Master Development Drainage Plan and
Preliminary Drainage Report

Peerless Farms
16975 Falcon Hwy
Peyton, CO 80831

PCD File No. SP-21-7

Master Development Drainage Plan and Preliminary Drainage Report
Peerless Farms – El Paso County, Colorado

EXISTING DRAINAGE MAP
 PEERLESS FARMS
 11/13/2023

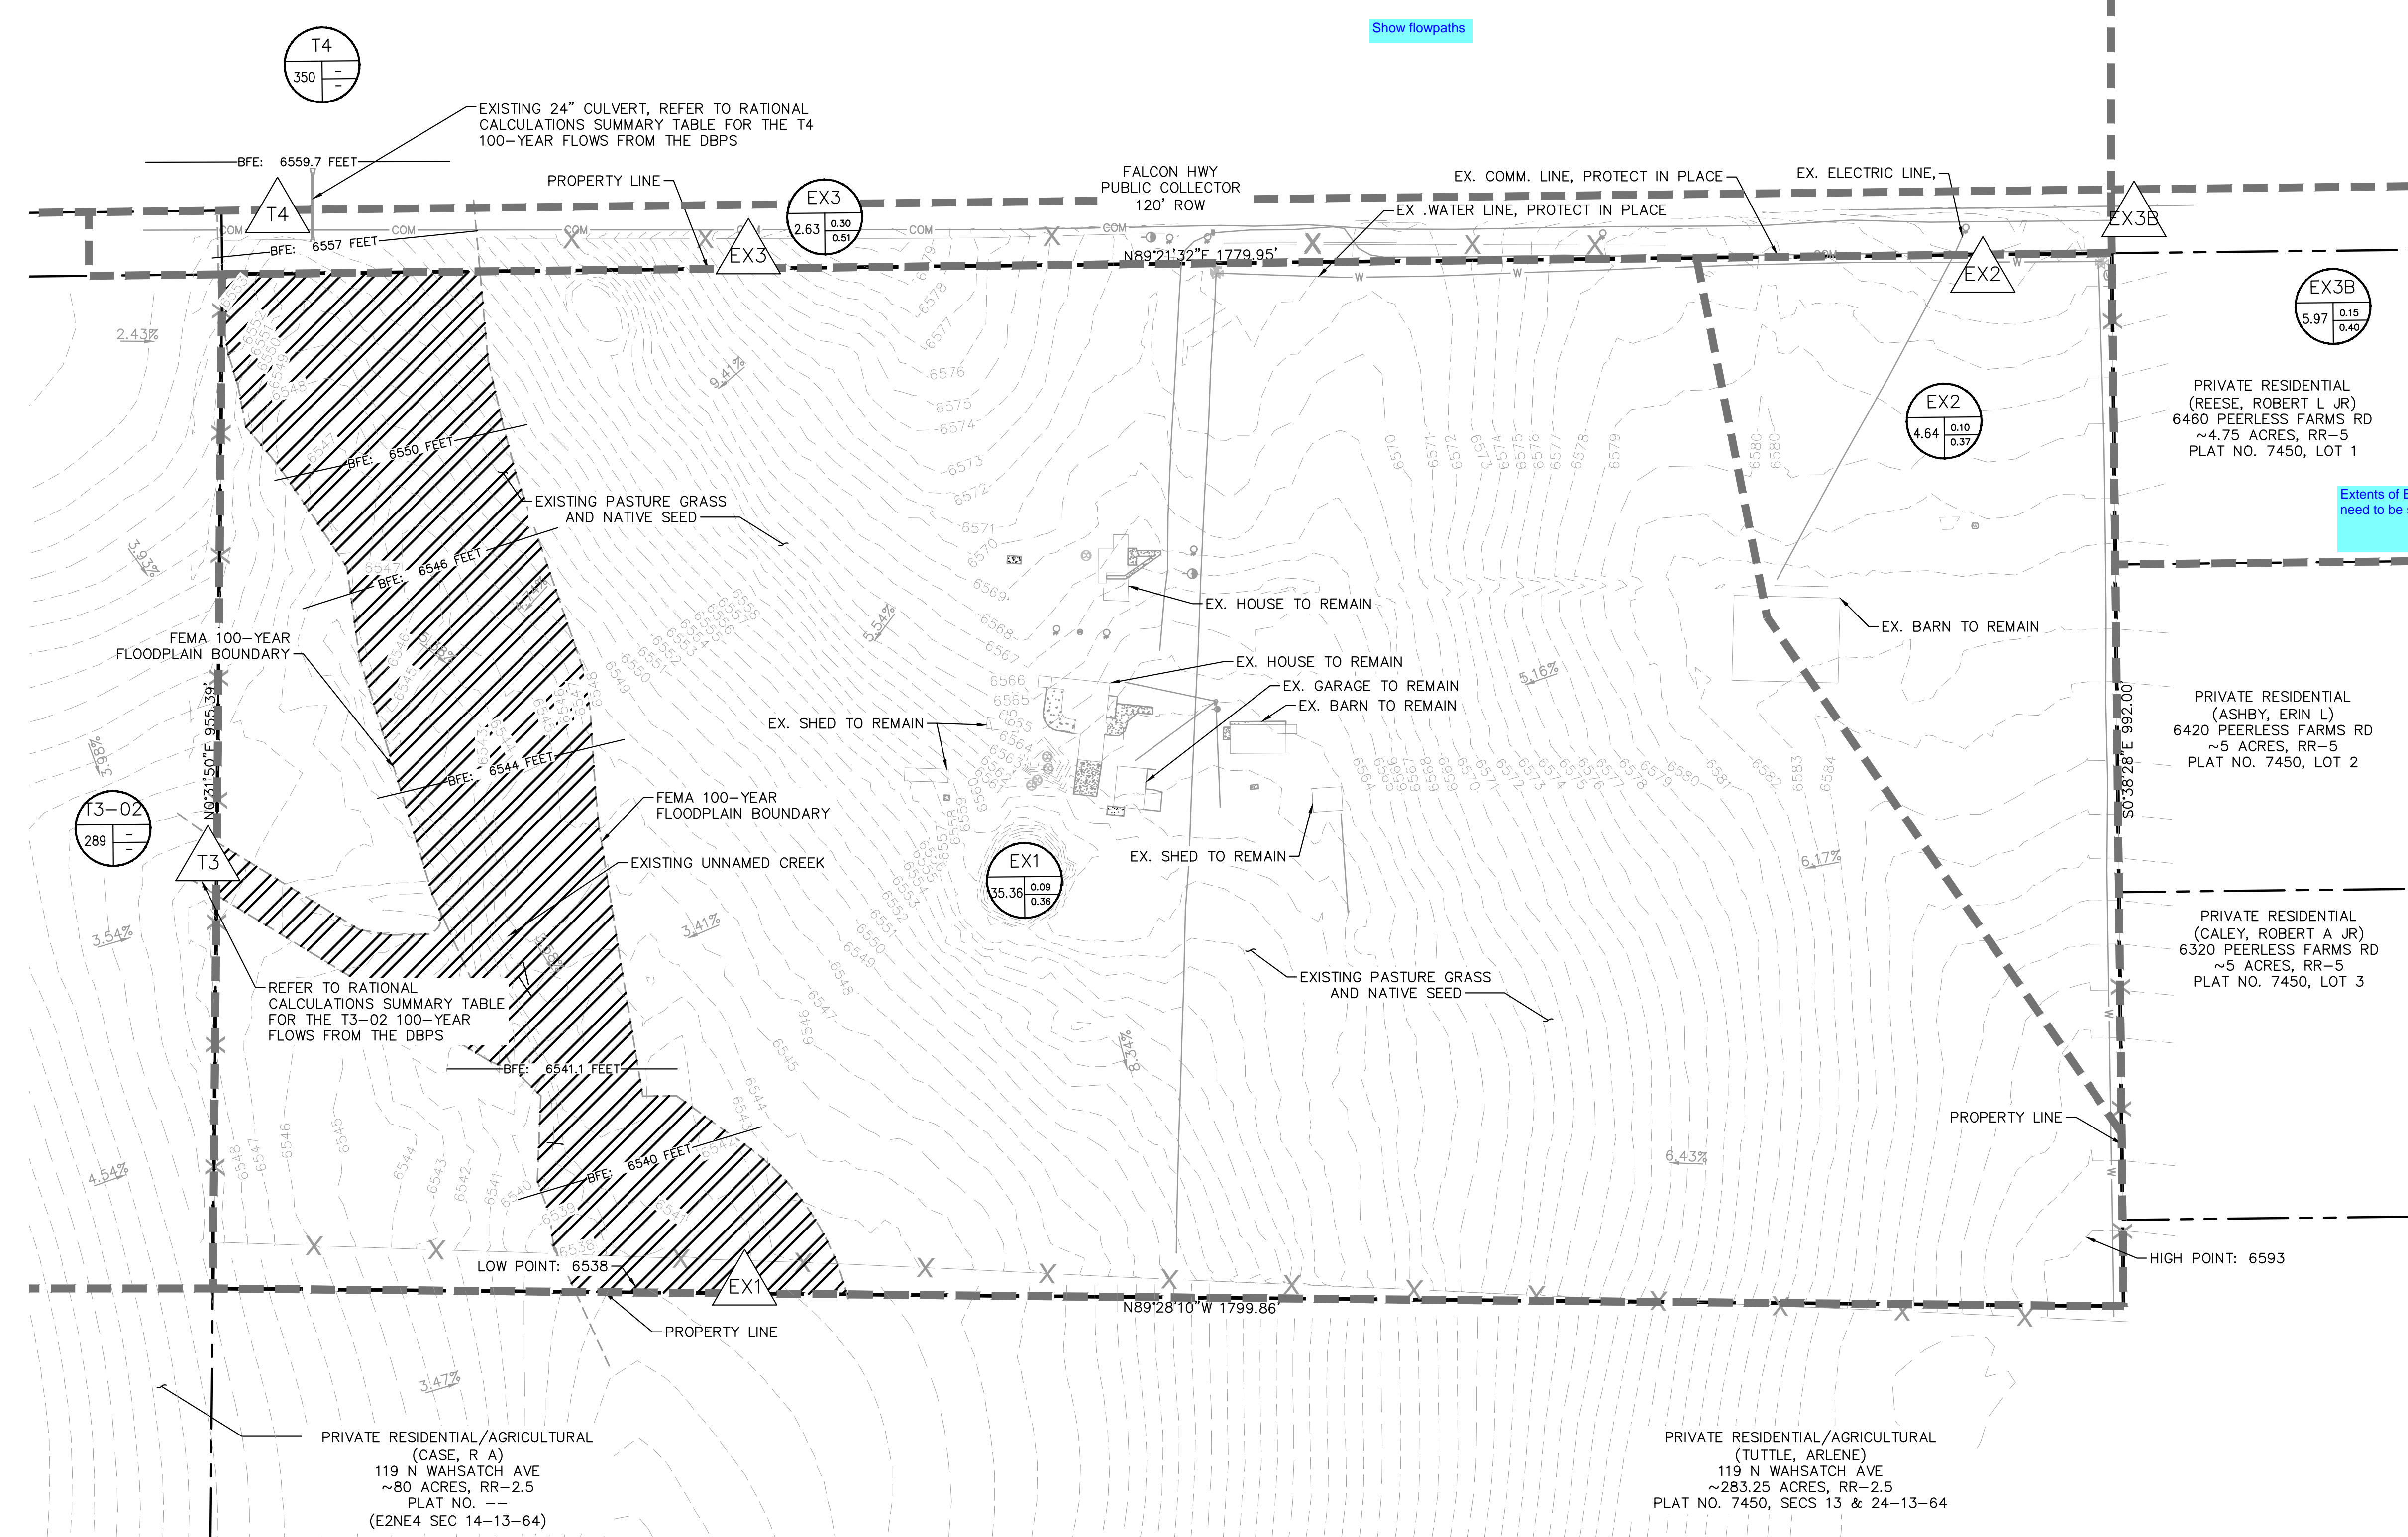
Extents of Basin EX3b need to be shown

PROPOSED DRAINAGE MAP
 PEERLESS FARMS
 11/13/2023

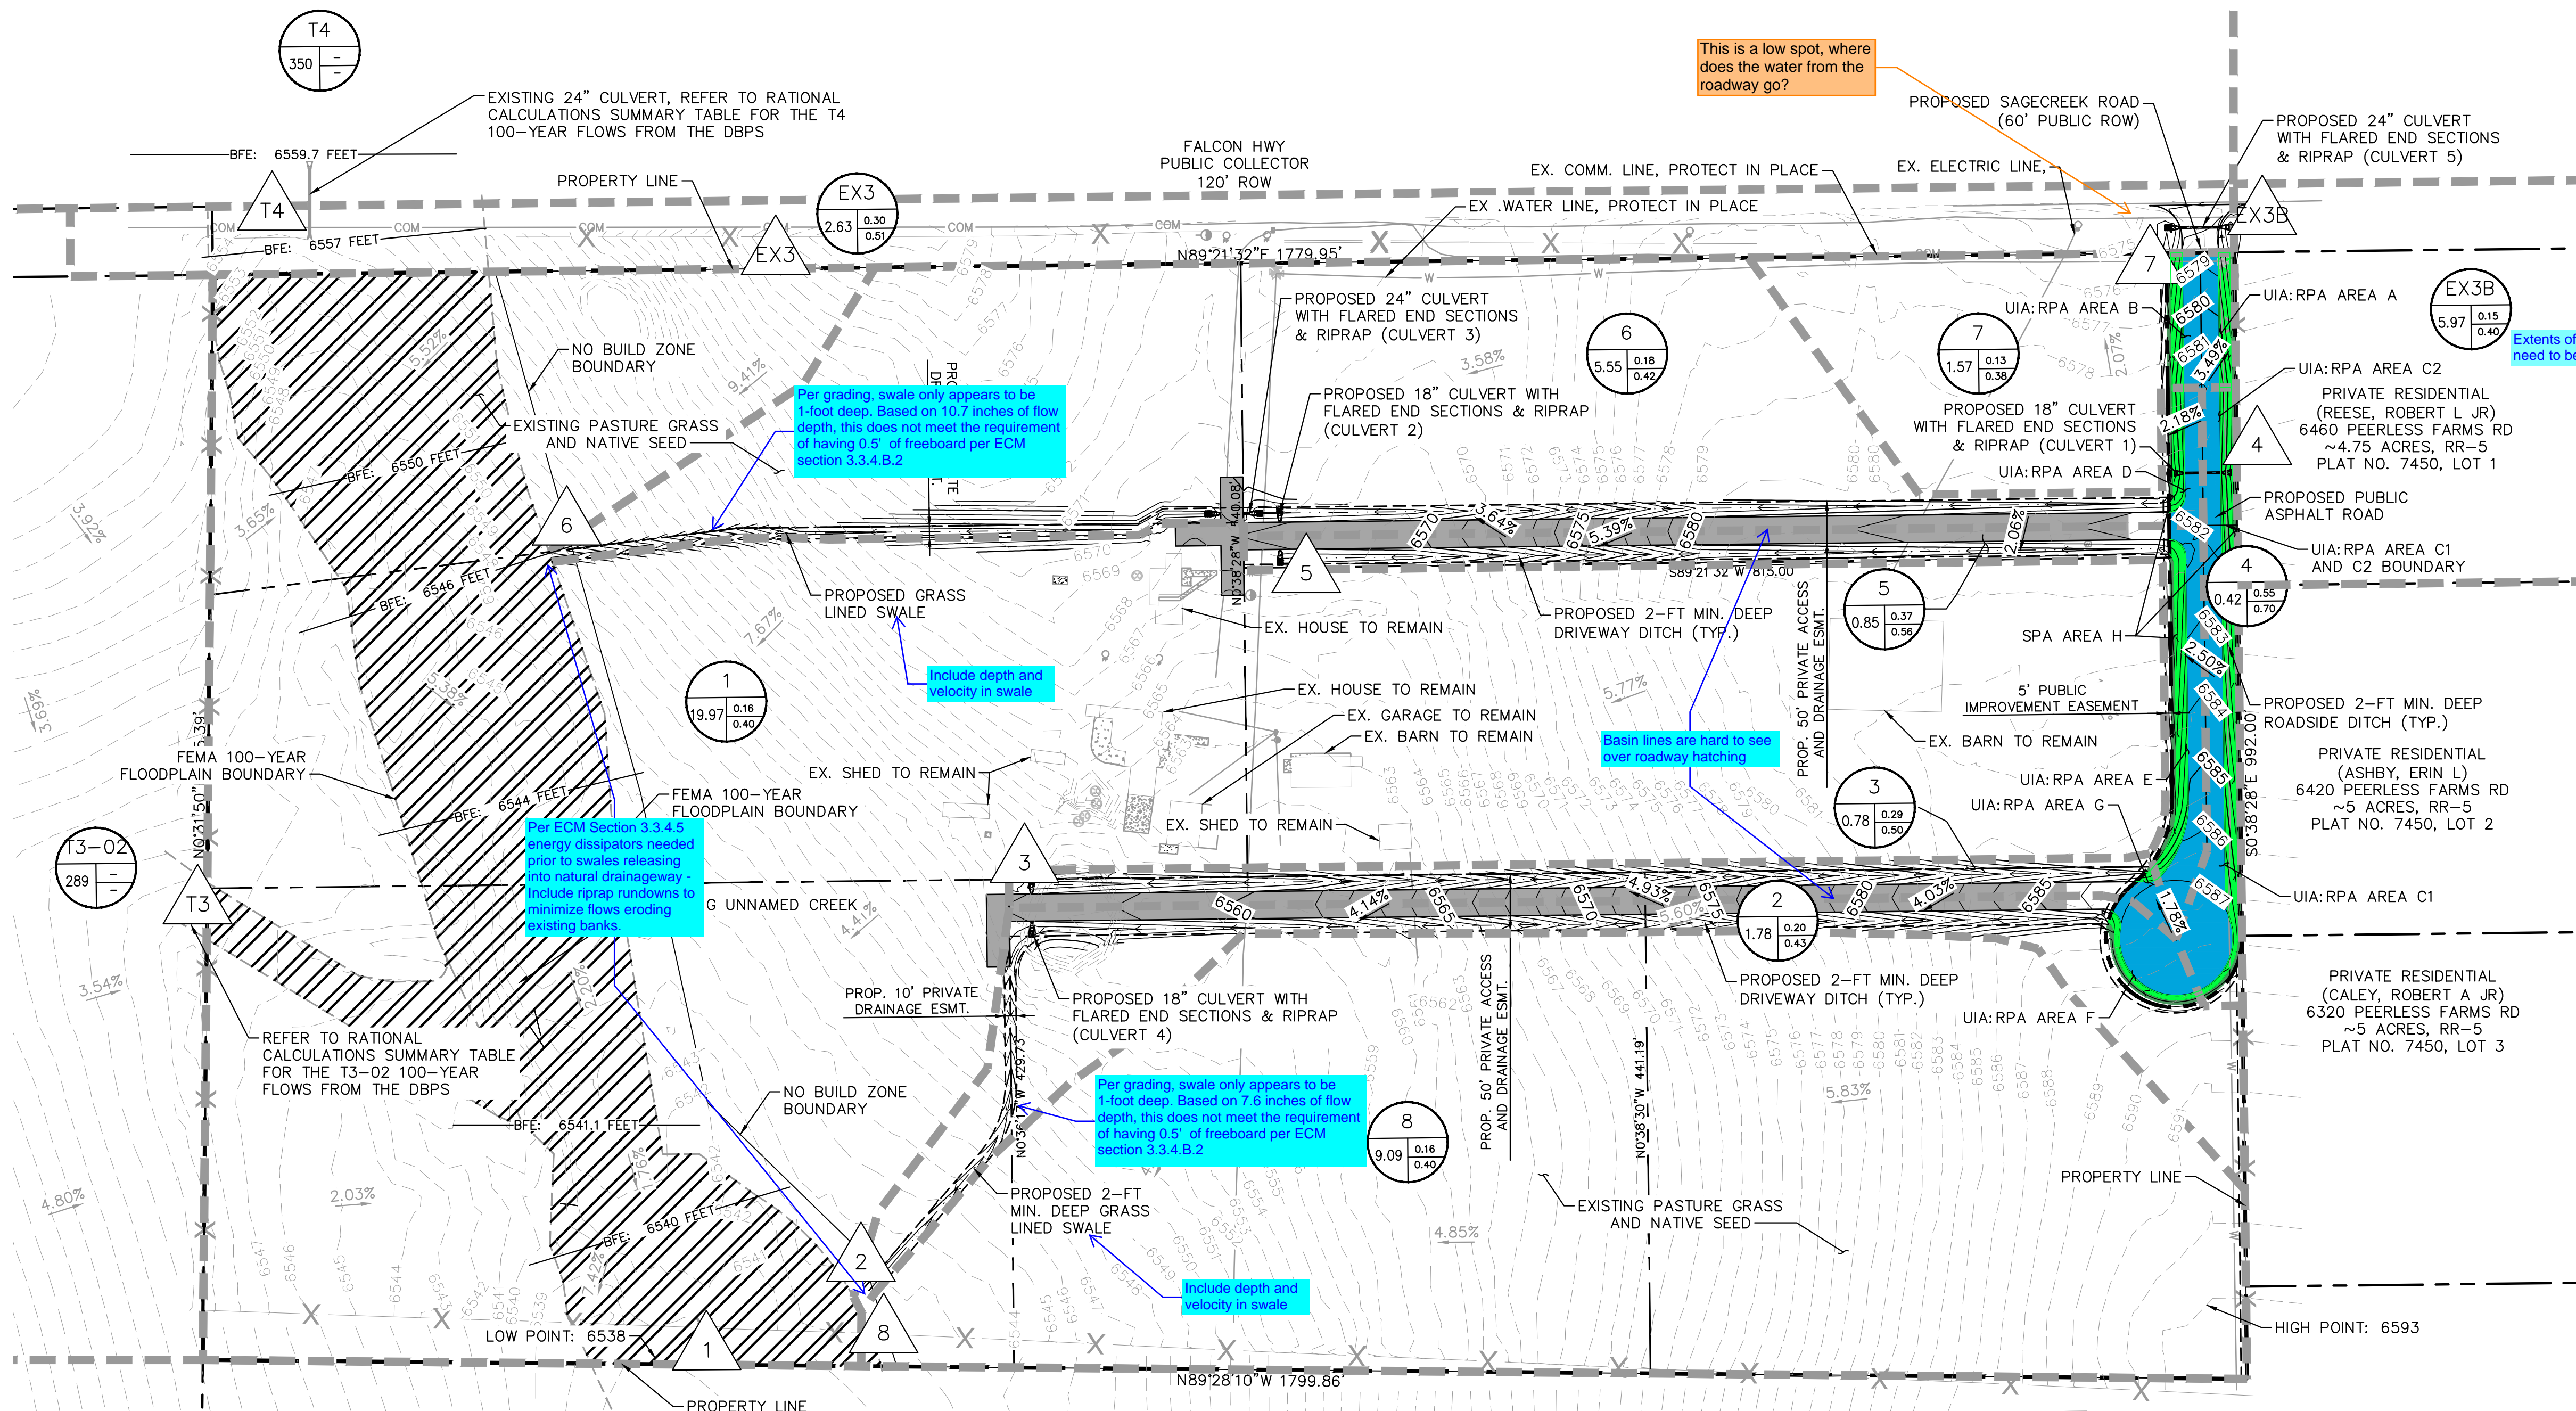
Show flowpaths

Show flowpaths
